**No. 94-10**

## OFFICIAL NOTIFICATION UNDER THE U.S. FEDERAL BOAT SAFETY ACT

### A. REQUIRED ENGINE GROUNDING STUD REPLACEMENT

MCM 4.3L Stern Drive Engines with 2 BBL Carburetors Only.

71651

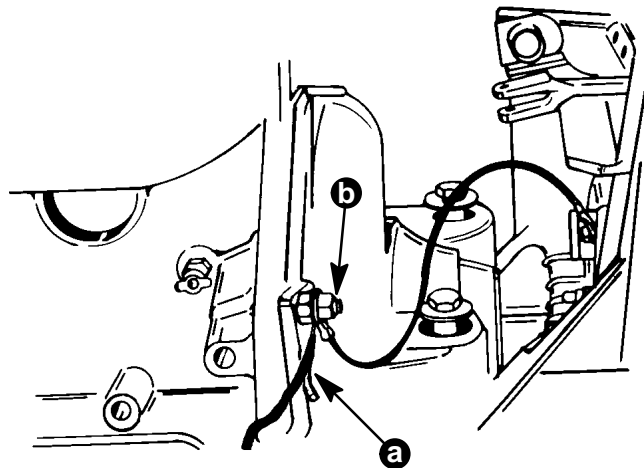
The 2 battery cable ground studs, located on the flywheel end of these engines, may not conduct a sufficient amount of electric current to ensure an adequate electrical ground. Without a good electrical ground, the electric choke grounding wire in the engine wiring harness could overheat and be damaged when the starter motor is engaged. This damaged ground wire could combine with gasoline fumes in the bilge to create a fire or explosion. See figure for the location of these 2 grounding studs.

- a - Negative (-) Battery Cable.
- b - Ground Stud (One Each Side of Engine). GRAY = Change, GOLD = Already Changed.  
Stud Torque: 27 lb. ft. (37 N.m.).

Look at color of both grounding studs. If the grounding stud is gold in color it does not need to be changed. If the grounding stud is gray in color, it does need to be changed. Remove the gray stud and replace it with the gold colored stud supplied by Mercury Marine.

(2) 16-64066 Ground Stud

71651

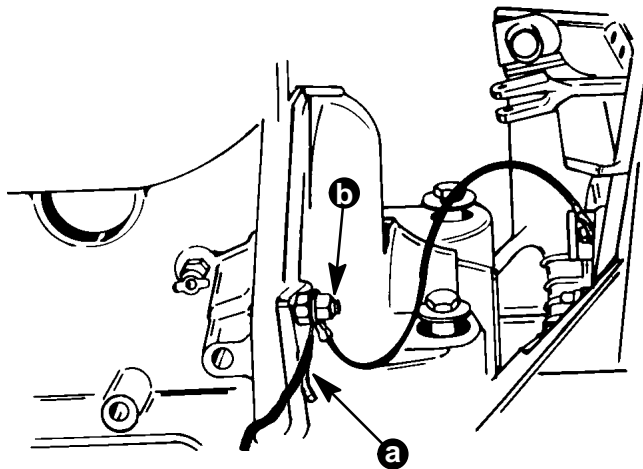
Your engine ground studs may not conduct a sufficient amount of electric current to ensure an adequate electrical ground. Without a good electrical ground, the electric choke grounding wire in your engine harness could overheat and damage the wire.

To determine if your engine is affected, the ground studs must be inspected. This can either be done by you or by your MerCruiser Dealer. The studs are located at the rear of the engine on either side of the flywheel housing (see diagram below). The easiest way to find the stud is to locate the negative battery cable at the battery and trace it to the engine ground stud. If the studs are a bright gold/bronze color they do not need to be replaced. In that circumstance, please fill out the enclosed reply card and return it to us by mail. If the studs are a dull gray color, make arrangements with your MerCruiser Dealer to have the studs replaced before you use your boat. If you do not wish to make the inspection yourself, please make arrangements to have the inspection made by your MerCruiser Dealer.

- a - Negative (-) Battery Cable.
- b - Ground Stud (One Each Side of Engine). GRAY = Change, GOLD = Already Changed.  
Stud Torque: 27 lb. ft. (37 N.m.).

Your MerCruiser dealer has been made aware of this situation by means of Service Bulletin 94-10. The Service Bulletin instructs the dealer on the proper procedure to procure the studs and make the necessary replacement. In most cases, the replacement should be able to be accomplished in an hour or less. The studs will be replaced without any cost to you. Mercury Marine apologizes for this inconvenience. We take this action in the interest of safety and your continued satisfaction with our product.
